4. TITLE AND SUBTITLE HYDRAZINE BLENDING AND STORAGE FACILITY, WASTEWATER TREATMENT AND DECOMMISSIONING ASSESSMENT, TASK 34, TECHNICAL PLAN, VERSION 3.2		5. FUNDING NUMBERS DAAK11 84 D 0017

HYDRAZINE BLENDING AND STORAGE FACILITY
WASTEWATER TREATMENT AND DECOMMISSIONING ASSE

RESPONSE TO COMMENTS

Figure 1-4.
SCHEMATIC LAYOUT, HYDRAZINE BLENDING
AND STORAGE FACILITY
ROCKY MOUNTAIN ARSENAL, TASK 34
Prepared by EBASCO Services, Incorporated

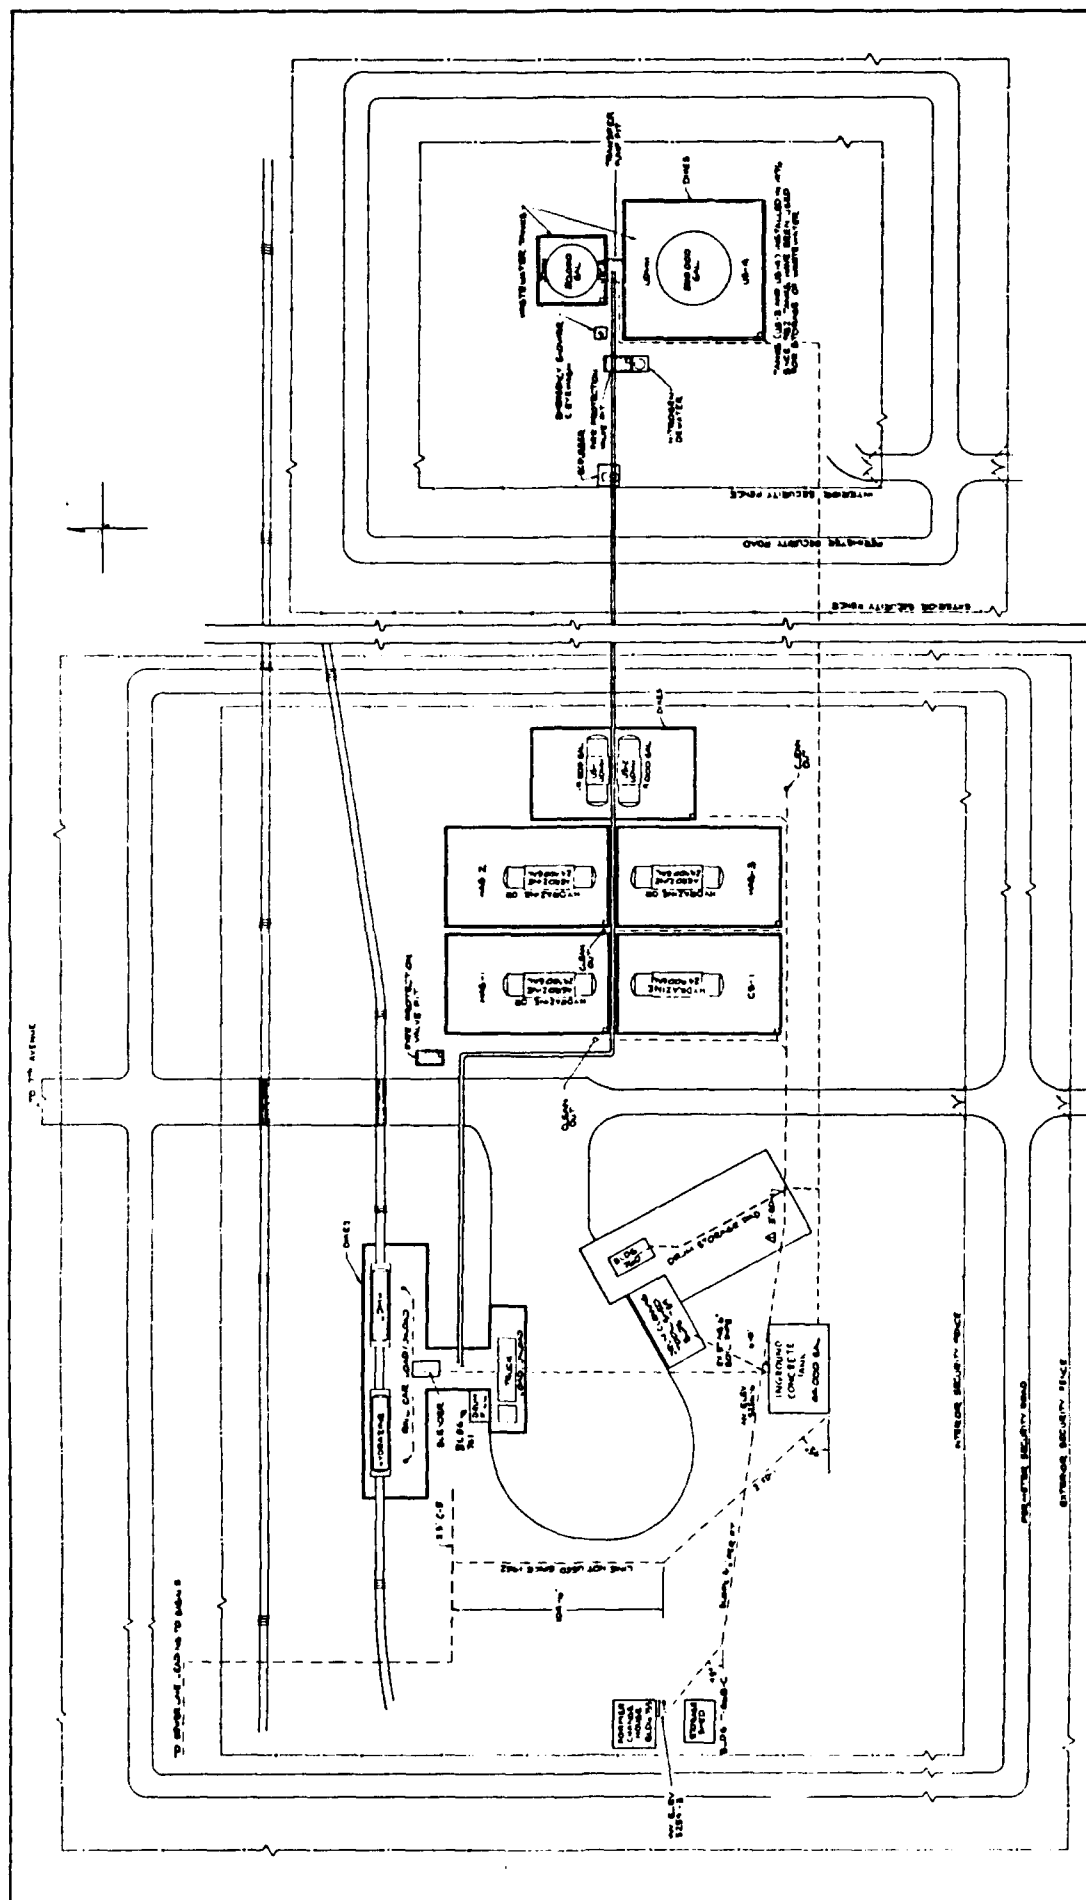
3. Figure 1-4 - No drain lines are shown from the drum storage pad to the in ground concrete storage tank. Are there any facilities to catch spills, or drum wash water?

Figure 1-4--No drain lines are shown from the drum storage pad to the inground concrete storage tank. Are there any facilities to catch spills, or drum wash water?
